UNITED STATES PATENT AND TRADEMARK OFFICE

APPLICATION NO.	FILING DATE	FIRST NAMED INVENTOR	ATTORNEY DOCKET NO.	CONFIRMATION NO.
10/727,673	12/04/2003	Ronald W. Kolb	20030403.ORI	8471
23595 7590 03/02/2007 NIKOLAI & MERSEREAU, P.A. 900 SECOND AVENUE SOUTH SUITE 820 MINNEAPOLIS, MN 55402			EXAMINER REESE, DAVID C	
			ART UNIT	PAPER NUMBER
			3677	
SHORTENED STATUTORY PERIOD OF RESPONSE		MAIL DATE	DELIVERY MODE	
3 MONTHS		03/02/2007	PAPER

Office Action Summary

DETAILED ACTION

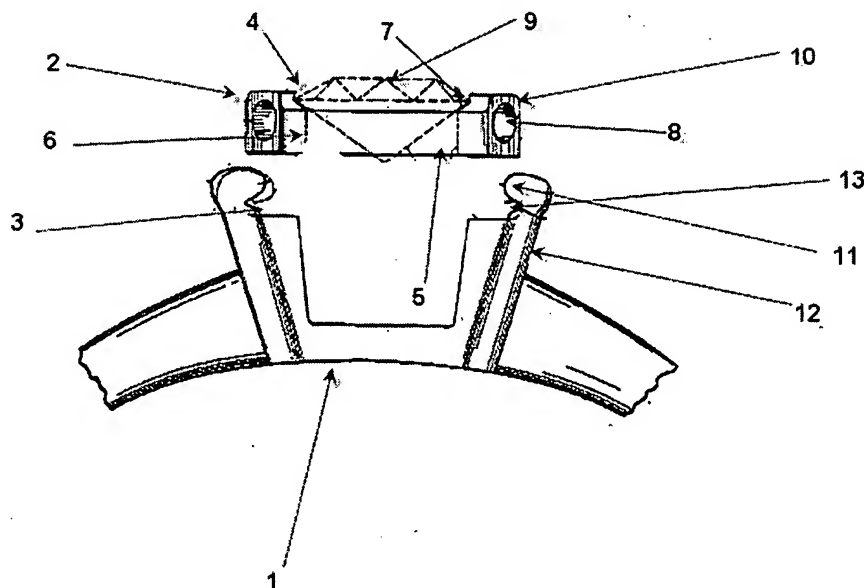
As for Claim 1, Thompson discloses of a ring (see figure below) comprising:

(a) a band (1);

(b) a hollow bezel (2) secured to a first portion (3) of said band (1) and having an open top (4), and open bottom (5), an inside wall (6) defining a lumen extending between said open top (4) and said open bottom (5), a seat (7) within said lumen (6), and an outside wall (10) having an exterior recessed section (8);

(c) a stone (9) mounted at least partially within said lumen (6) of said bezel (2) and in contact with said seat (7); and

(d) a hook (11) at a second portion (12) of said band (7) and having an opening (13) sized to receive the recessed section (8) of said bezel (2) to clasp the two portions (3, 12) of the band (1) together, wherein when said hook (11) has received the recessed section (8) of said bezel (2), the hook (11) is impeded from detaching from the bezel (2) by either the top or bottom of said

bezel (2) (it would take force to detach the bezel, so therefore it is considered “impeded” from detaching from said bezel).

Re: Claim 3, wherein said band (1) has spring characteristics (part 3, line 64, stating, “In the initial position...toward the center of the head just far enough to be sprung slightly outwardly as...”)) such that the band (1), hook (11) and bezel (2) all cooperate to hold the inside of the hook (11) against the exterior recessed section (8) of the bezel (2) as the piece of jewelry is worn.

Re: Claim 5, wherein the outside wall (10, including that of 8) of said bezel (2) has a substantially hour-glass shape (due to the “concave exposed area in which is formed a socket” represented by 8; the concavity of the socket gives the outside wall a hour-glass shape).
